**QUALITY ASSURANCE -- NON-CONFORMANCE REPORT**

**Location:** Changxing Island, Shanghai, P.R. China**Report No:** NCR-000622**Prime Contractor:** American Bridge/Fluor Enterprises, a JV**Date:** 11-Jan-2010**Submitting Contractor:** Zhenhua Port Machinery Company, Ltd (ZPMC), Changxing Island**NCR #:** ZPMC-0595**Type of problem:**

**Reference Description:** Weld repair of transverse cracks without the Engineer's approval on Segment 5AE Deck to Side Panel

<b>To:</b>	AMERICAN BRIDGE/FLUOR, A JV 375 BURMA ROAD OAKLAND CA 95607	<b>Date:</b>	11-Jan-2010
<b>Dear:</b>	Mr. Charles Kanapicki	<b>Contract No:</b>	04-0120F4 04-SF-80-13.2 / 13.9
<b>Attention:</b>	Mr. Thomas Nilsson Project/Fabrication Manager	<b>Job Name:</b>	SAS Superstructure
<b>Subject:</b>	NCR No. ZPMC-0595	<b>Document No:</b>	05.03.06-000585

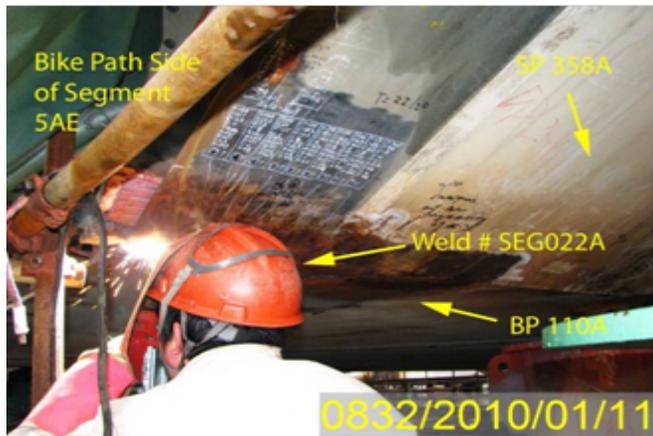
During the Quality Assurance in-process observations of the fabrication of lift 5 East, the QA inspector discovered the following issues:

- Weld repair of transverse cracks without the Engineer's approval.
  - No approved welding procedure specification (WPS) was onsite during the welding repair process.

- The weld is identified as "Hold Back" weld #SEG022A-007
  - The weld is a Complete Joint Penetration (CJP) weld.
  - The weld is joining bottom panel identified as BP110A to the side panel identified as SP558A

- Location is nearest to panel point 032 on the bike path side of segment (@ E3 line).
  - Repair is being performed due to eleven (11) transverse indications being discovered in a 325mm area by the contractor using the Ultrasonic Testing (UT) method.

- Y location of repair is noted to be between 20mm~345mm near the 5AE+4BE field splice.
  - Lift 5 East is located in the OGB Trial Assembly Area.
- 
- The weld is a Complete Joint Penetration (CJP) weld.

Propose a resolution for the identified non-conformance with revised procedures to prevent future occurrences. Notify the engineer and have WPS's onsite prior to the start of the repair.

**Reference Resolution:** ZPMC has repaired the UT indications noted in the NCR and is providing the CWR that was used as well as the NDT performed after to show that the weld is acceptable.

This proposed resolution is acceptable. The documentation received is sufficient and the Department concurs that Non-Conformance ZPMC-0595 is closed.

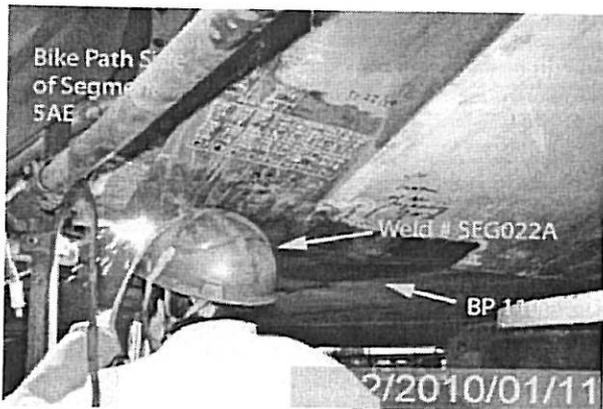
During the Quality Assurance in-process observations of the fabrication of lift 5 East, the QA inspector discovered the following issues:

- Weld repair of transverse cracks without the Engineer's approval.
- No approved welding procedure specification (WPS) was onsite during the welding repair process.
- The weld is identified as "Hold Back" weld #SEG022A-007
- The weld is a Complete Joint Penetration (CJP) weld.
- The weld is joining bottom panel identified as BP110A to the side panel identified as SP558A
- Location is nearest to panel point 032 on the bike path side of segment (@ E3 line).
- Repair is being performed due to eleven (11) transverse indications being discovered in a 325mm area by the contractor using the Ultrasonic Testing (UT) method.
- Y location of repair is noted to be between 20mm~345mm near the 5AE+4BE field splice.
- Lift 5 East is located in the OGB Trial Assembly Area.

- The weld is a Complete Joint Penetration (CJP) weld.
- The weld is joining bottom panel identified as BP110A to the side panel identified as SP558A
- Location is nearest to panel point 032 on the bike path side of segment (@ E3 line).
- Repair is being performed due to eleven (11) transverse indications being discovered in a 325mm area by the contractor using the Ultrasonic Testing (UT) method.
- Y location of repair is noted to be between 20mm~345mm near the 5AE+4BE field splice.
- Lift 5 East is located in the OGB Trial Assembly Area.

Submit CWR and perform NDT required to verify weld quality.

Contractor submitted CWR after repairs were completed. Additional repairs were required after said incident. NDT documentation was submitted verifying the weld is now in conformance with Contract specifications.
